SERVICE ACTION

Reference number:	SA-23-1425	Issued: 24 October, 2020
Subject:	Incorrect Reminder for Second-Row Seatbelts	
Model(s):	DBX	
VIN range:	Refer to the separately published list of affected Vehicle Identification Numbers (VINs)	
Applicable to:	All Dealers	
Distribute to:	After Sales Manager Service Manager Sales Manager	Warranty Staff Technician(s) Parts Staff

Reason for this Service Action

Figure 5

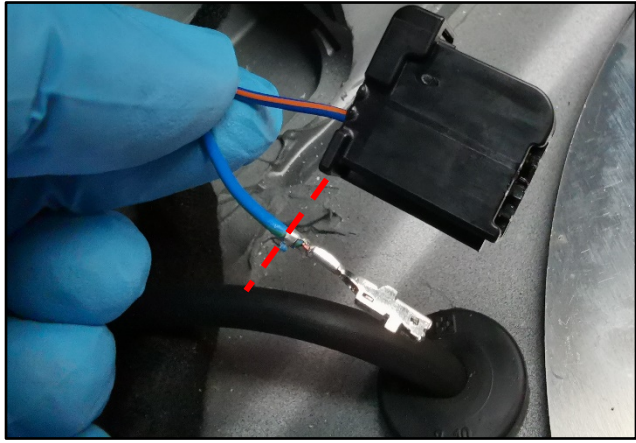
7. Use the applicable tool to remove the existing terminal (refer to Figure 5).

CAUTION: DO NOT REMOVE MORE LENGTH THAN IS NECESSARY.

Figure 6

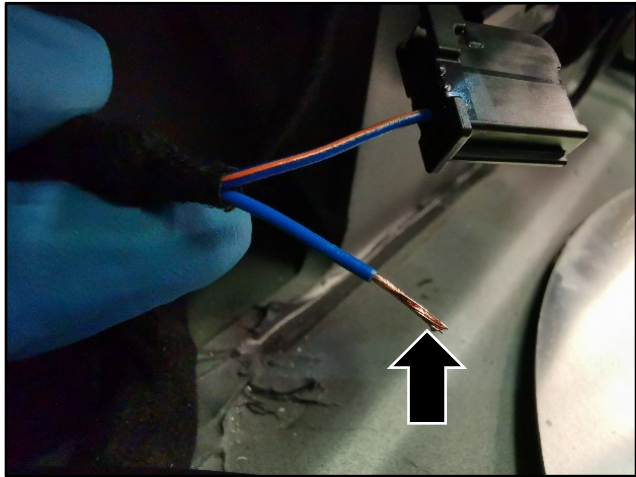
8. Remove approximately 5-7mm of the insulation at the end of the wire (refer to Figure 6).

CAUTION: DO NOT REMOVE MORE LENGTH THAN IS NECESSARY.

Figure 7

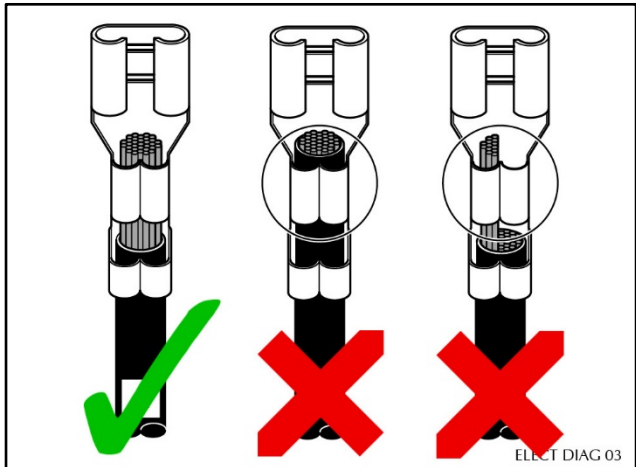
9. Use the applicable tool to install a new terminal onto the wire.

CAUTION: MAKE SURE TO INSTALL THE WIRE IN THE CORRECT POSITION. (REFER TO FIGURE 7)
